GW-035

General Correspondence

PROJECT PLAN

San Juan Gas Plant TK-1300 Replacement and Impermeable Containment Construction

SAN JUNI GAS PLANT APRONISIAS FOR WASTE BINS

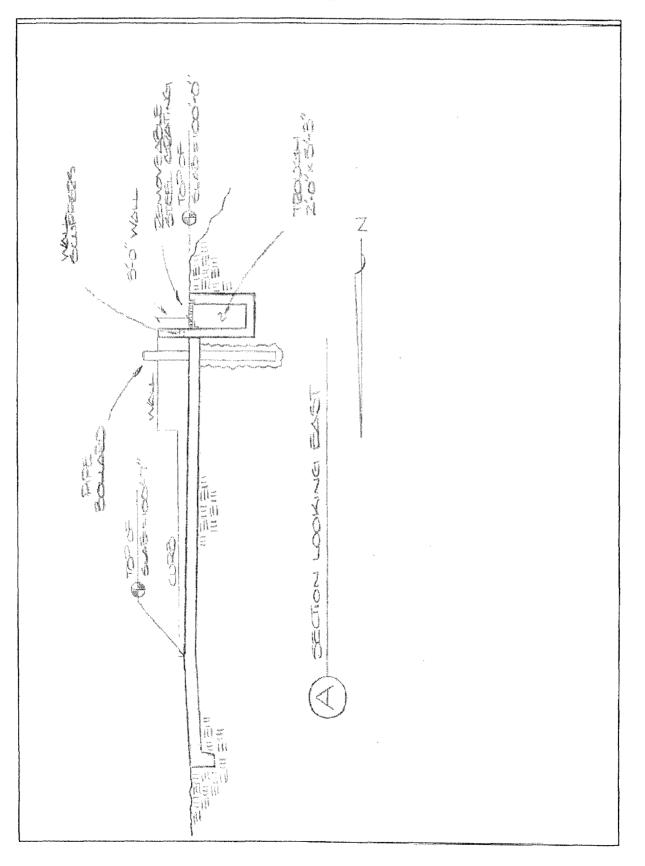
The OCD approves your design for the new bins on the following condition:

The 2' x 5' troughs be used as sumps and not below grade tanks. Sumps are meant to catch fluids BUT not to contain them indefinitely. If fluids are kept within these sumps they will automatically be categories as Below-Grade tanks and will need to be re-engineered with a secondary containment with a leak detection system.

TK-1300 EQUIPMENT LUBE OLL TAKE AND CONCRETE CONTAINMENT BASIN

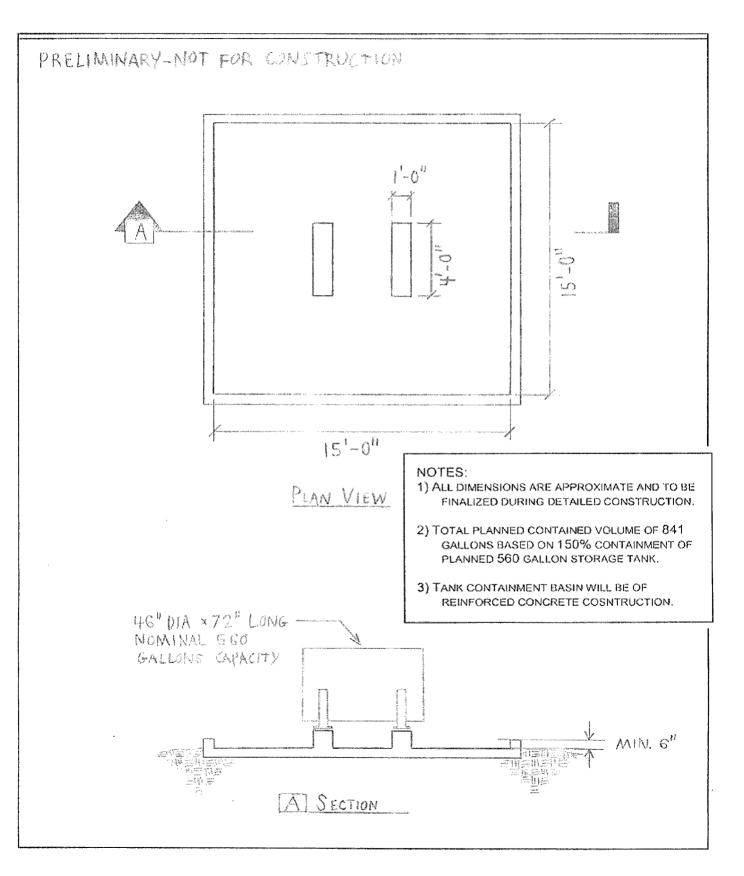
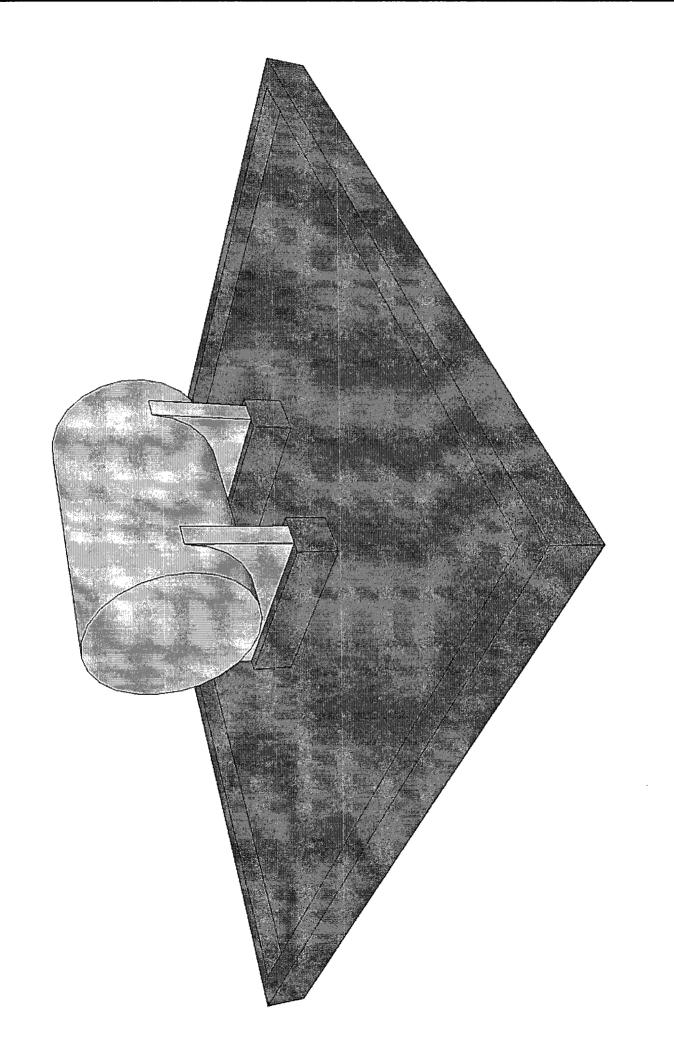
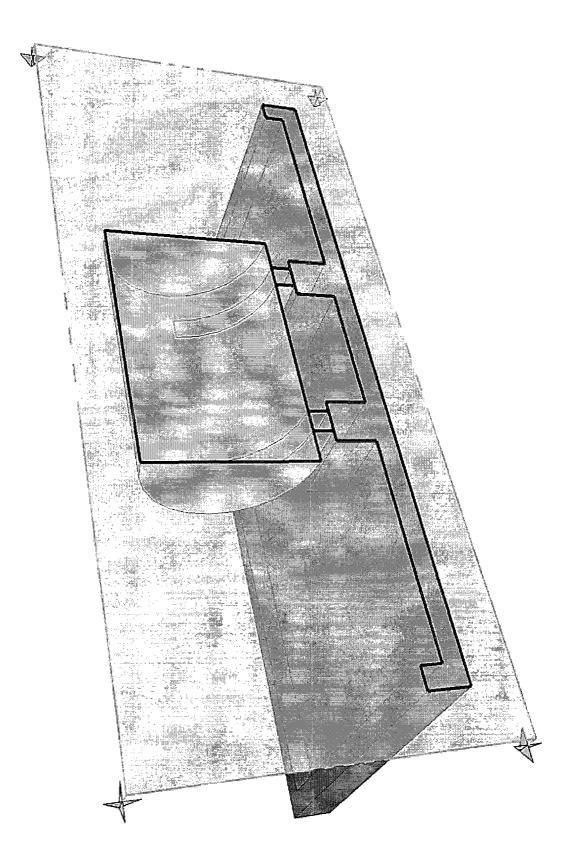
The OCD **approves** your plan to replace the existing earthen bermed tank to a new impermeable padded containment with smaller tank.

In section 2.6 *Commission New Tank TK-1300*: If you are to use tap water for these test. I would suggest that testing be done on the water before and after test. Test to WQCC 3103, except for Uranium, and Radioactivity. I will research this in more detail and will submit additional information.
